## ADDENDUM #01

ACES at CHASE

STATE PROJECT NO. 244-0044 MAG

6. **ALL Bidders** should review and incorporate the **attached Bulletin #1 dated December 16, 2025** prepared by **S/P+A** and their consultants. This Addendum includes:

Drawing Number:  
**E400-1**

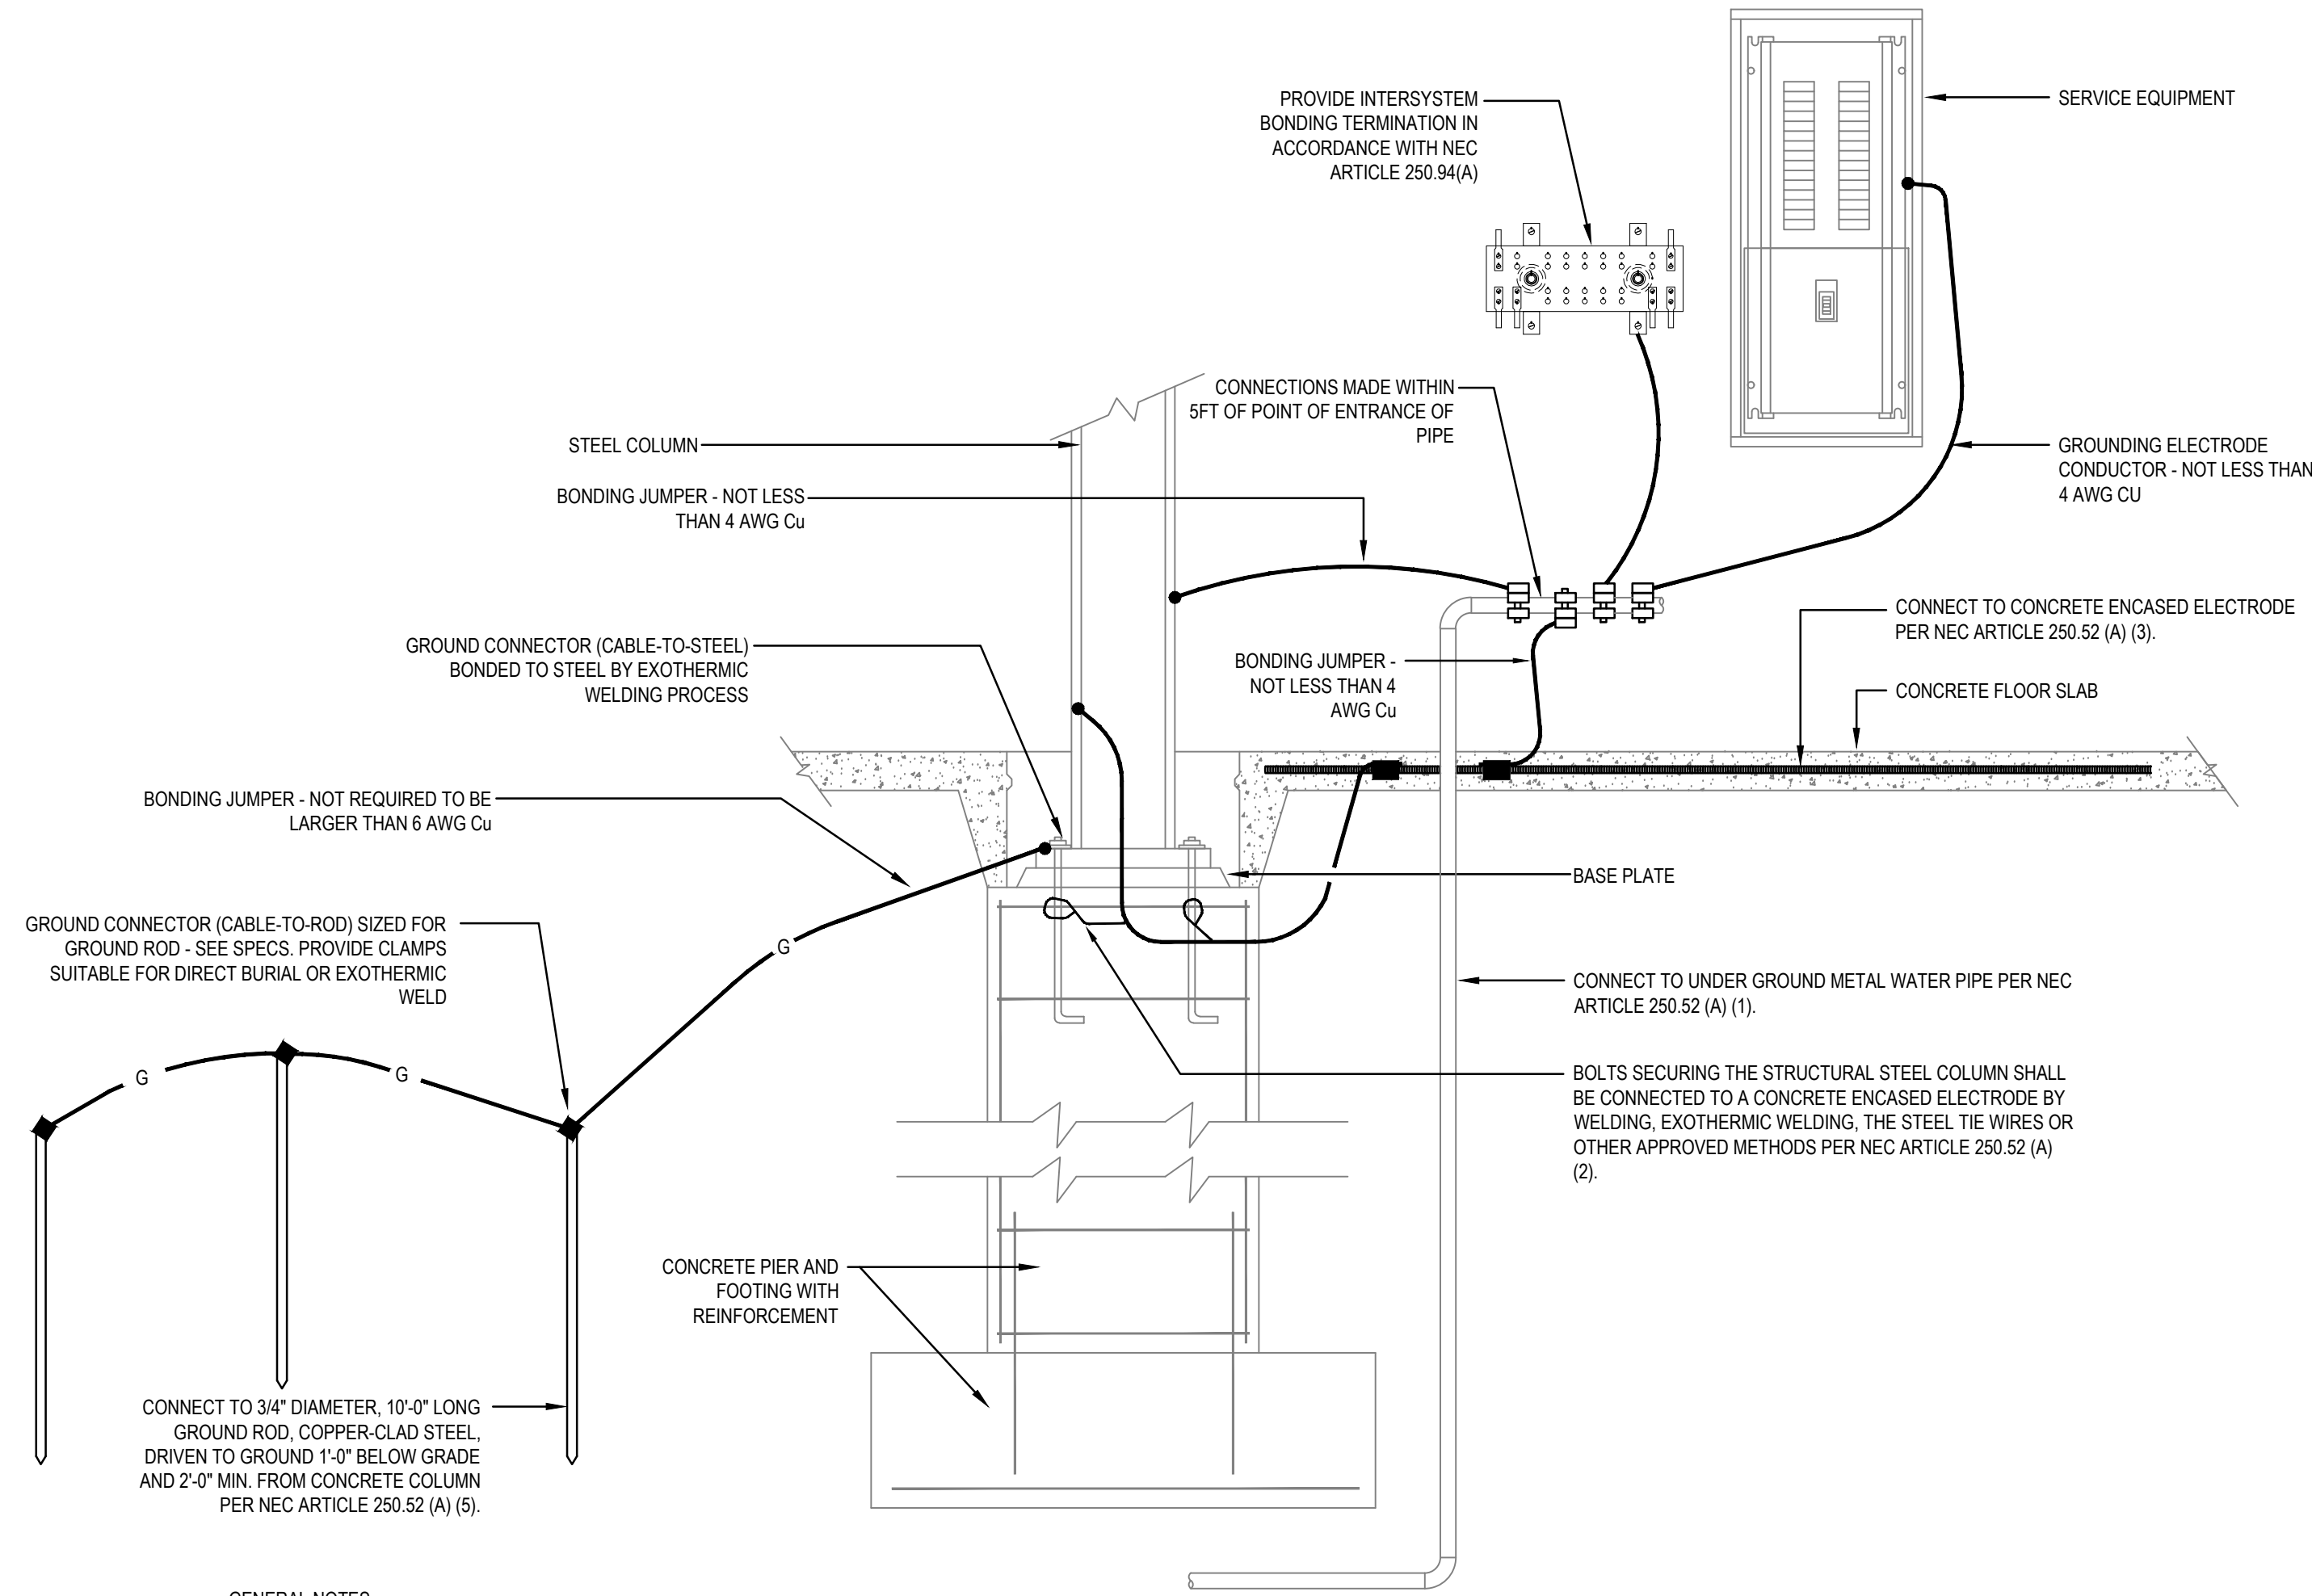
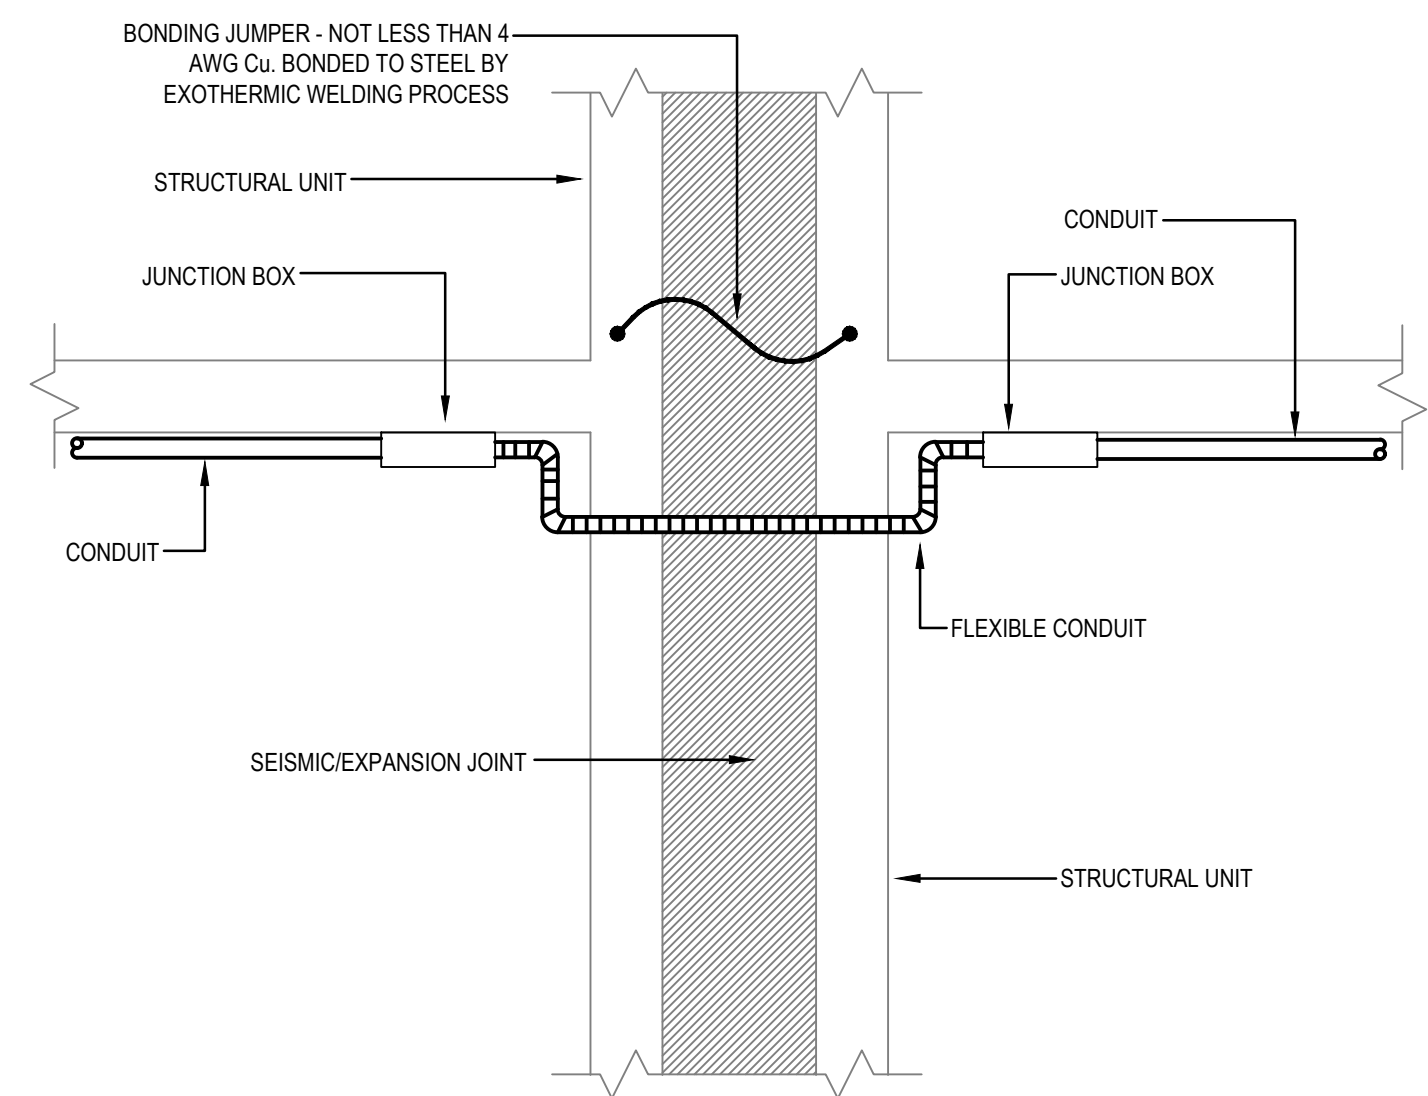
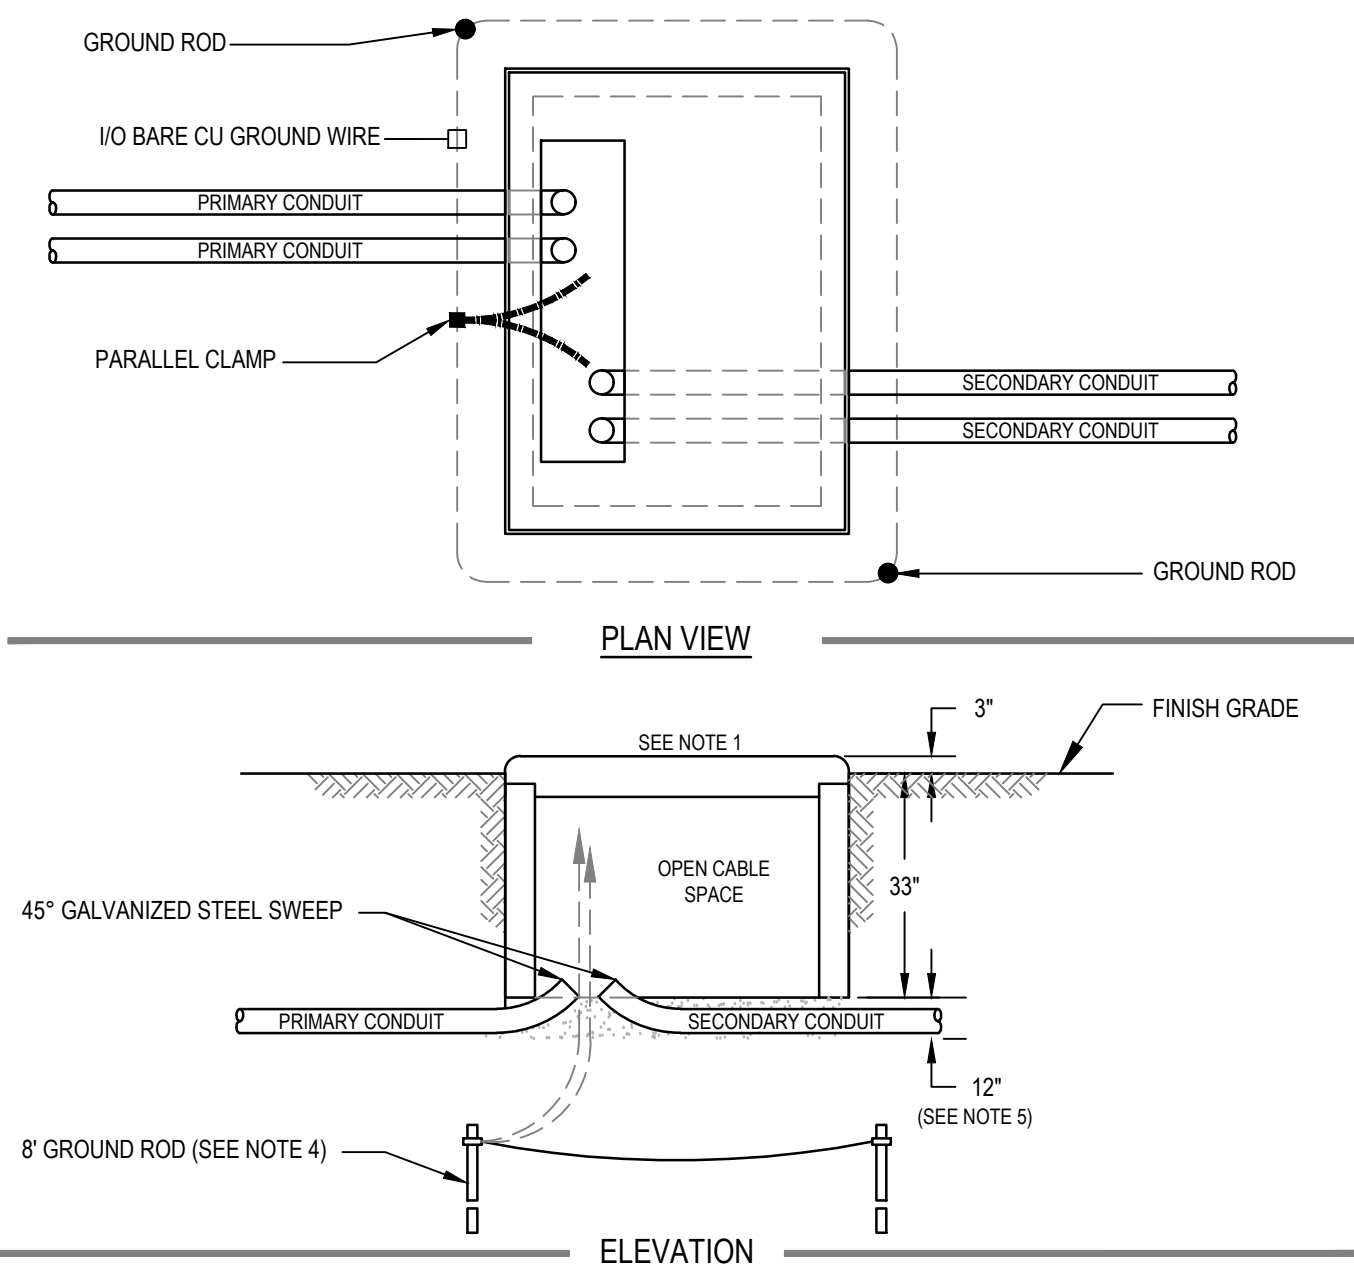
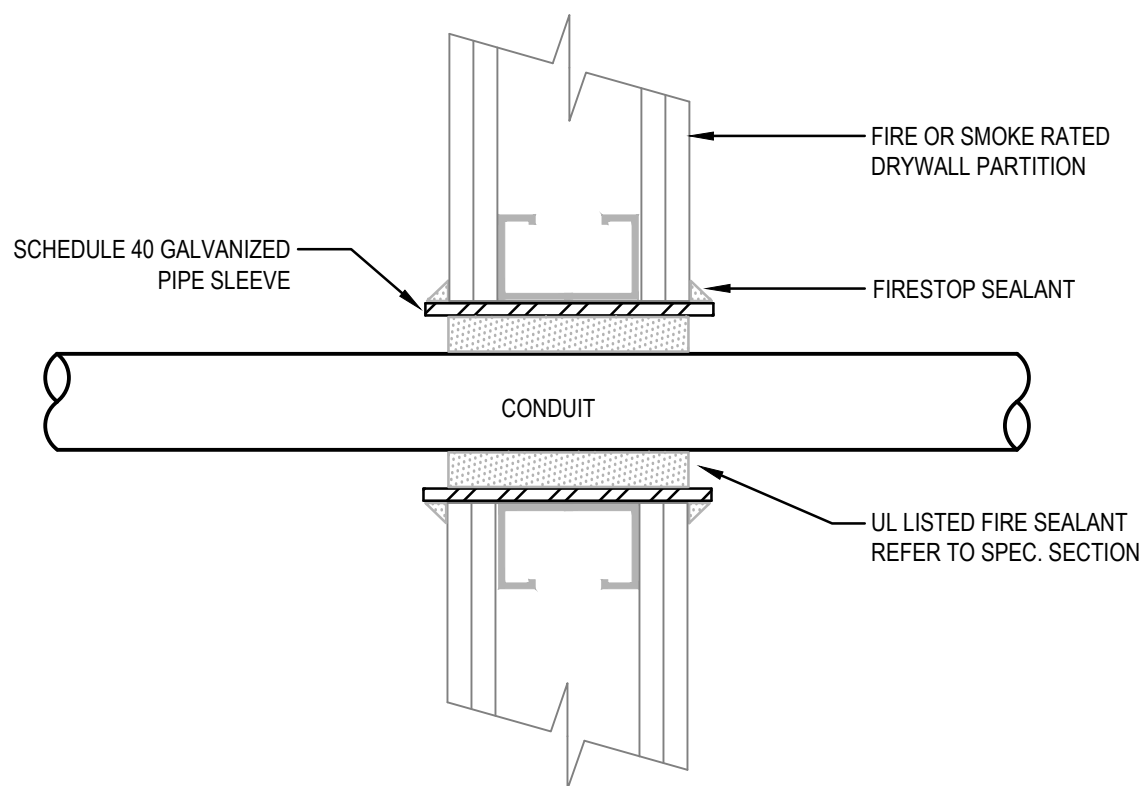
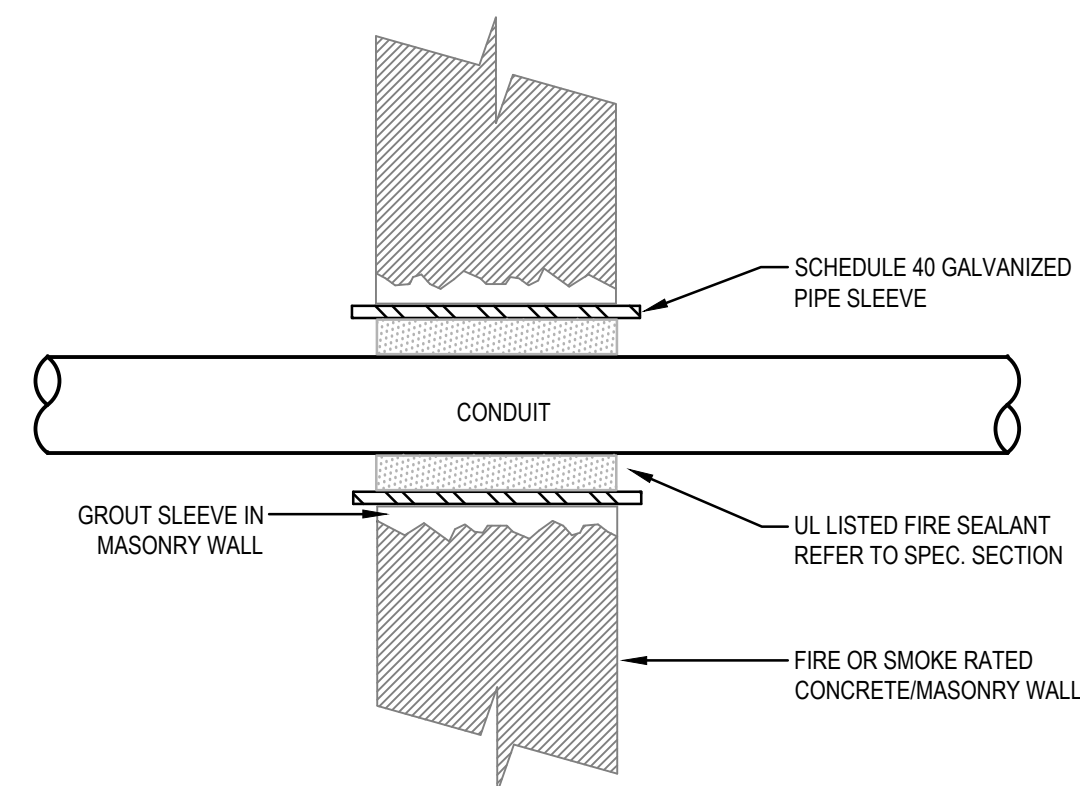
- E230-1 BUILDING 1 – THIRD LEVEL POWER PLAN *(Per Internal Review)*
    - E400-1 BUILDING 1 – DETAILS *(Per Cx)*
  - Building 2:
    - The following ELECTRICAL drawings have been deleted in their entirety. New drawings (4) have been added and are attached as part of this bulletin\*:
